AUTOMOBIL- UND MOTOREN-WERKE  
BREMEN - GERMANY

## Trunk Lid "Isabella"

**A**  
**216**

Bremen, August 20th, 1957

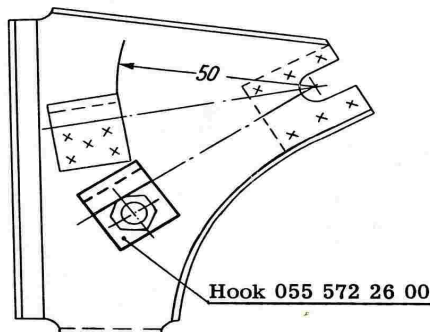
It now has become apparant that in case of special load of the trunk lid by attachment of lamps, illuminated identification shields etc. the torsion bar springs partly cannot take up this addition of weight. The trunk lid does not remain in opened position then but turns back again.

In such cases this can be easily rectified by fitting of an additional hook on both sides on the supporting brackets for the springs.

As shown in above drawing the attachment of the hook is made with a bolt, spring washer and nut (M 6) each. For this purpose the supporting brackets must be drilled, which is efficiently done with the aid of a drill extension from the center of the trunk support. The retightening of the torsion bar springs is made by clamping of the offset ends in these hooks.

It is also recommended to make these alterations in case of springs, which have no longer sufficient tension.
